PROJECT NAME:
ARMC
SITE RENOVATIONS
PLAN

SHEET TITLE:
OVERALL SITE
GRADING PLAN

C2.1

PROPOSED SITE GRADING PLAN
SCALE: 1" = 30' (22X34)
SCALE: 1" = 60' (11X17)

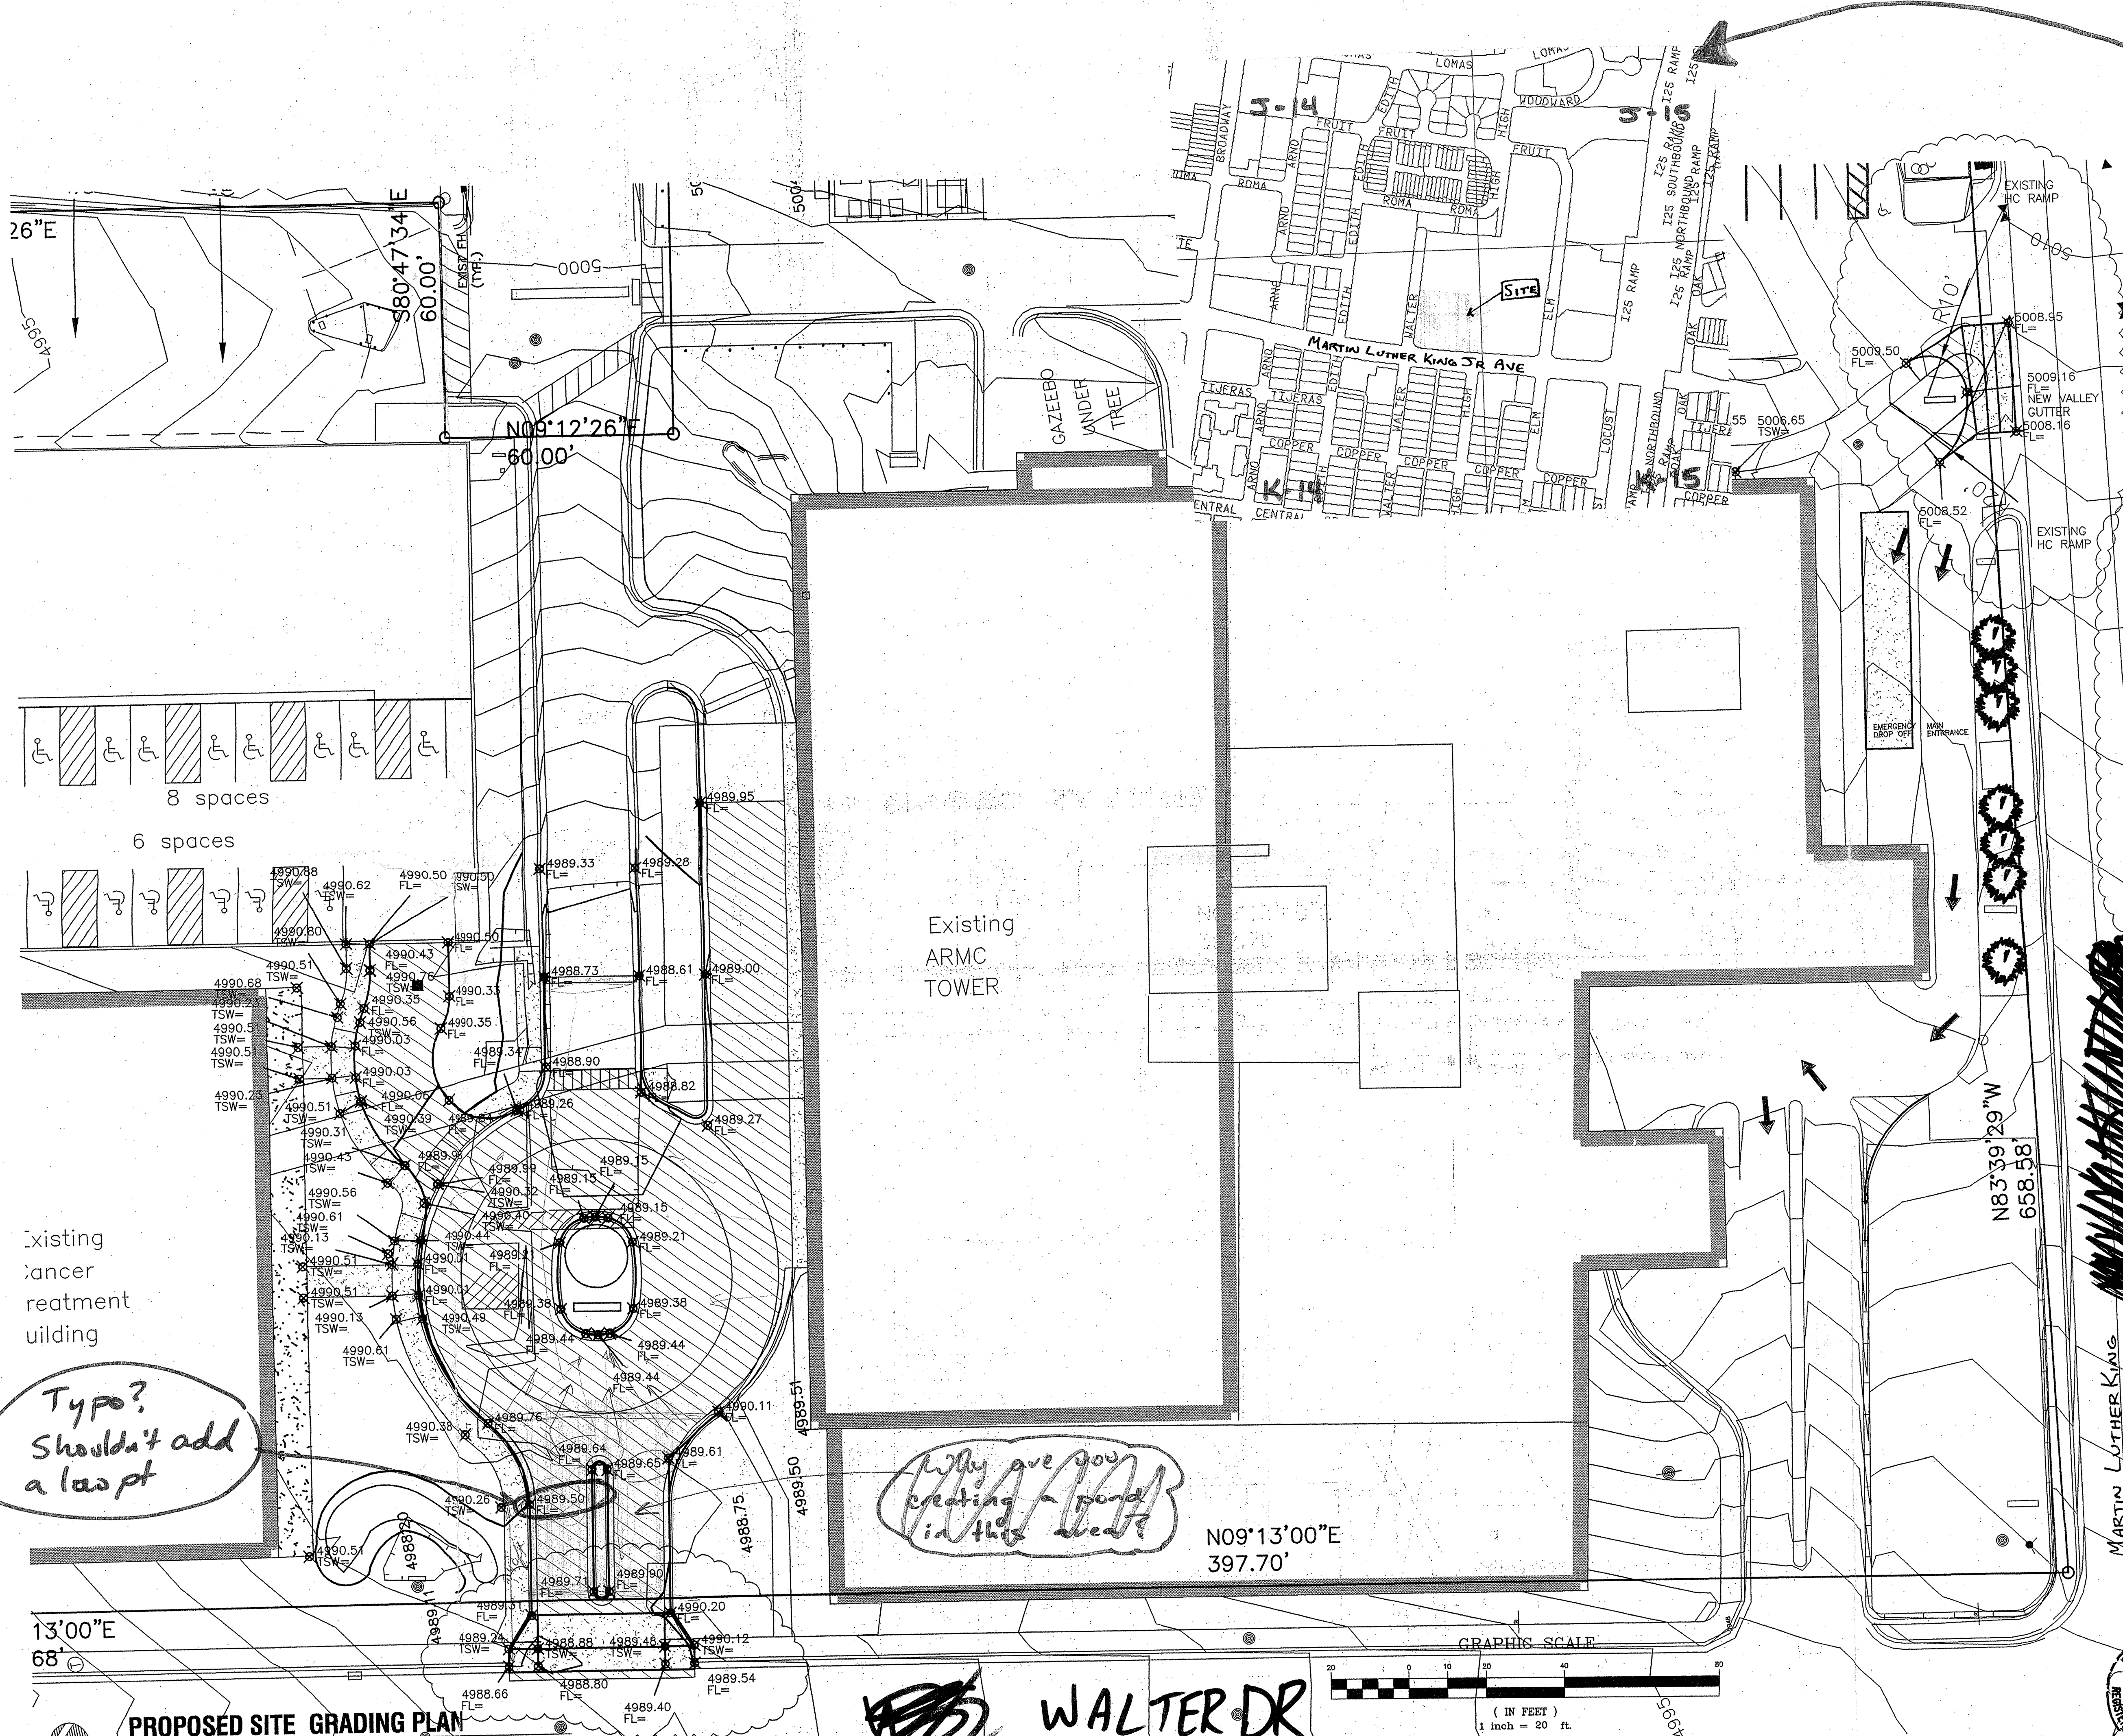
Typo?
Shouldn't add
a last pt

Why are you
creating a pond
in this area?
